From: Shreekant Patel
Sent: 17 April 2026 15:41
To: Kwaku Bossman-Gyamera
Subject: HGY/2026/0754 - 11, High Cross Centre, Fountayne Road, Haringey, London, N15 4QL

Transport comments as follows:

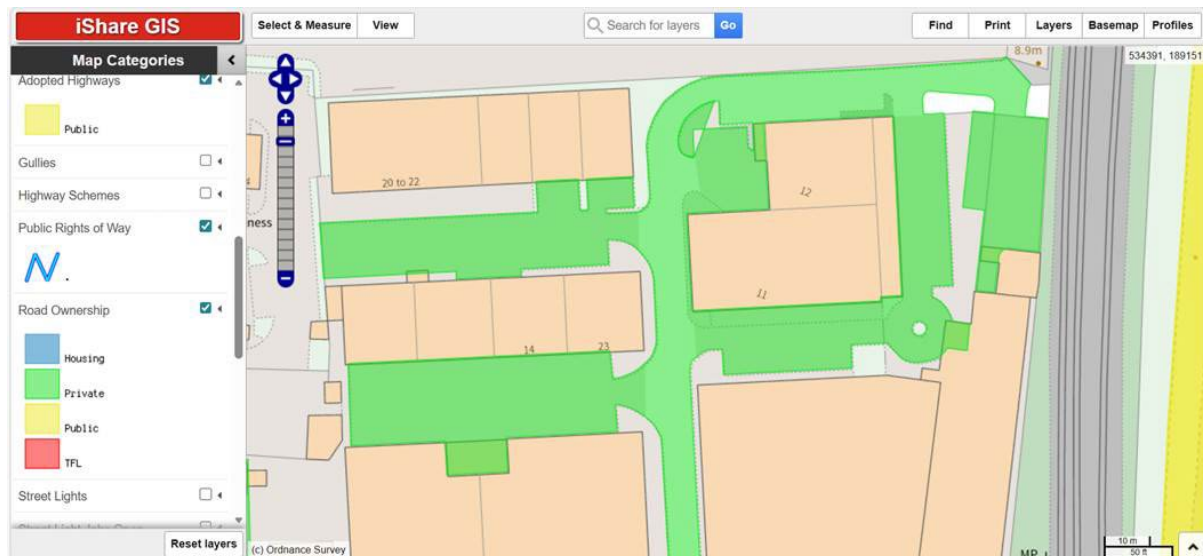
- b. The roads adjacent to the site are 'private' – as shown below (coloured Green). Please provide detail of parking enforcement that is in place.
